Groundwater Application Review Summary Form

Application # G- 18445

PUBLIC INTEREST REVIEW FOR GROUNDWATER APPLICATIONS

SUBJECT: Application G- 18445 Supersedes review of _____
Date of Review(s)

Stream-Depletion Model Results

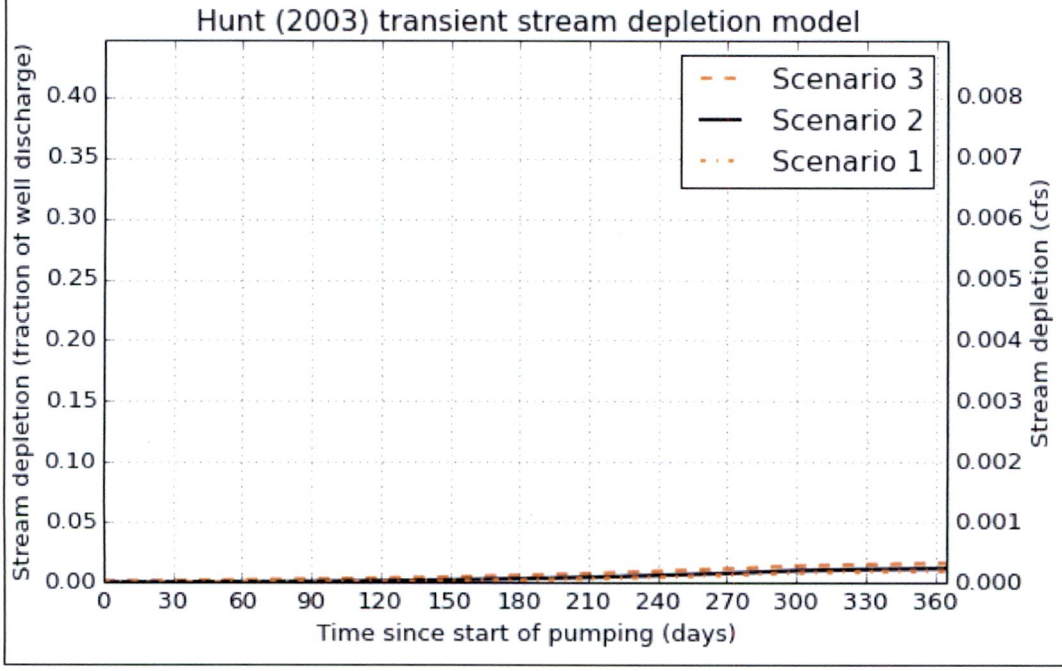
Comments: Interference @ 30 days was estimated using the Hunt (2003) analytical model and aquifer parameter values appropriate for the local geology; model results are attached

C6. **SW / GW Remarks and Conditions:** The proposed POA would be producing from an aquifer that has been found to be hydraulically connection to surface water. The proposed rate is greater than 1% of both the 80%-exceedance natural flows and the pertinent instream right so PSI is assumed under OAR 690-009. However, estimated interference is far less than the requirement of 25% after 30 days. If the proposed rate were reduced to < 0.0026 cfs (1680 gal/day) than PSI would no longer be assumed.
